SUBJECT: COMANCHE PEAK NUCLEAR POWER PLANT, UNITS 3 AND 4  
DOCKET NUMBERS 52-034 AND 52-035  
RESPONSE TO REQUEST FOR ADDITIONAL INFORMATION NO. 6124  
(SECTION 9.4.5), 6159 (SECTION 3.11), 6222 (SECTION 3.9.6), AND 6265  
(SECTION 14.3.7)

Luminant Generation Company LLC (Luminant) submits herein the response to Requests for Additional Information (RAIs) No. 6124 (CP RAI #243), 6159 (CP RAI #239), 6222 (CP RAI #244), and 6265 (CP RAI #245) for the Combined License Application for Comanche Peak Nuclear Power Plant Units 3 and 4. The RAIs address the ultimate heat sink ventilation system, the environmental qualification program, and inservice testing.

Figure 9.4-2031 UHS ESW Pump House Ventilation Systems Flow Diagram

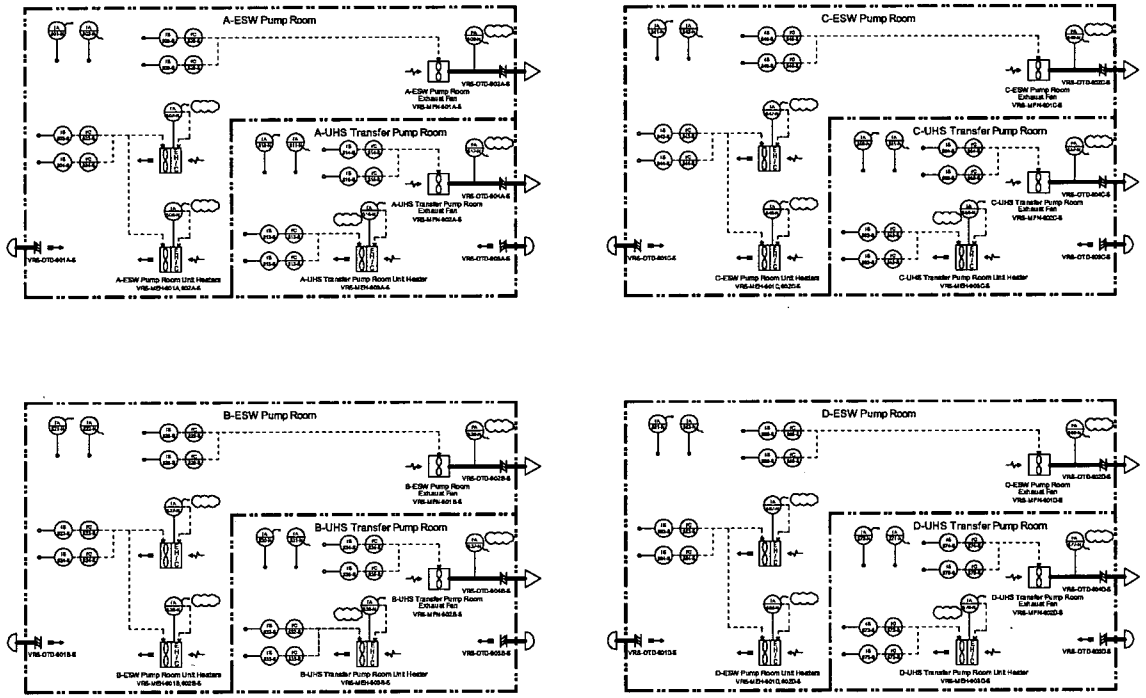
The staff notes that Revision 2 FSAR Figure 9.4-203 "UHS ESW Pump House Ventilation Systems Flow Diagram" has a "STD COL 9.2(6)" identifier. In Revision 1 of the RCOLA FSAR, Figure 9.4-201 (changed to Figure 9.4-203 in Revision 2) was tagged with a "CP COL 9.4(6)" identifier. The staff believes this is a typographical error that warrants correction as it is doubtful that "STD COL 9.2(6)" could apply to this drawing.

The staff believes that "STD COL 9.4(6)" is the appropriate tag for FSAR Figure 9.4-203. The staff requests the applicant provide a response about this issue and requests that the RCOL applicant amend the FSAR as necessary.

FSAR Revision 2 Figures 9.4-201 and 9.4-202 were deleted in FSAR Revision 2 Update Tracking Report Revision 0 submitted on December 20, 2011 (ML12012A101 and ML12012A140), and Figure 9.4-203 was renumbered as Figure 9.4-201. The left margin notation on FSAR Revision 2 Figure 9.4-201, "UHS ESW Pump House Ventilation Systems Flow Diagram," has been corrected to read "STD COL 9.4(6)."

Figure 9.4-2031 UHS ESW Pump House Ventilation Systems Flow Diagram

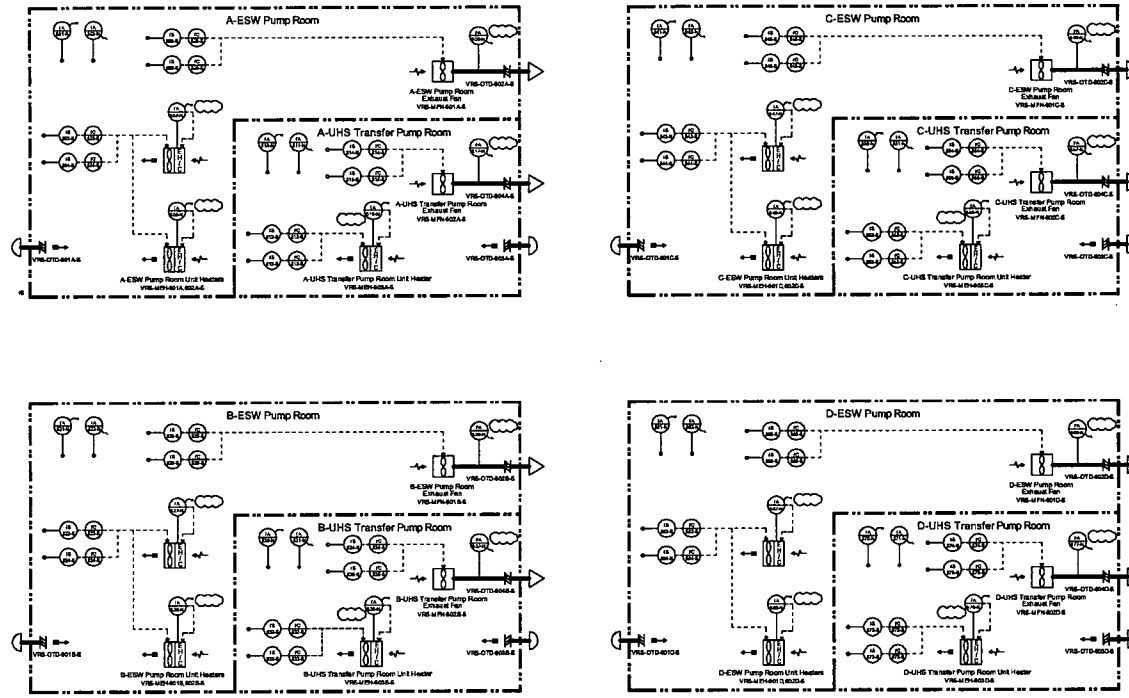
The staff notes that Note 1 of FSAR Figure 9.4-203 (i.e. changed to 9.4-203 with Revision 2 of FSAR from 9.4-201) does not address the seismic category of instrumentation (e.g. flow switches, temperature switches) attached to the unit heaters and exhaust fans. Nor does the Note address the seismic classification of the detached temperature switches and temperature controllers contained within the pump rooms. The staff notes that FSAR Table 3.2-201 also fails to address the seismic classification of the UHS ESW Pump House Ventilation System’s instrumentation. The staff also notes that Revision 2 FSAR Figure 9.4-203 “dropped” the display of the MCR alarms discussed in FSAR subsection 9.4.5.5.6. These high and low area temperature alarms were previously displayed in Figure 9.4-201 (Revision 1 of RCOLA)

The staff requests the applicant provide additional information about these issues and amend FSAR Figure 9.4-203 and FSAR Table 3.2-201 to remove these technical deficiencies from the FSAR.

The response to Question 09.04.05-3 is correct. The fans, heaters, and dampers are all safety-related components and are Seismic Category I. The ventilation system has safety-related and non-safety related instruments associated with the HVAC system components. The safety-related instrumentation is Seismic Category I and the non-safety related instrumentation is Seismic Category II.

Figure 9.4-201, “UHS ESW Pump House Ventilation Systems Flow Diagram,” has been revised to designate safety-related and non-safety related instrumentation as shown in the figures in DCD

Section 1.7. Note 1 and Note 5 of Figure 9.4-201 show that safety-related components and instruments are Seismic Category I and non-safety related instruments are Seismic Category II.
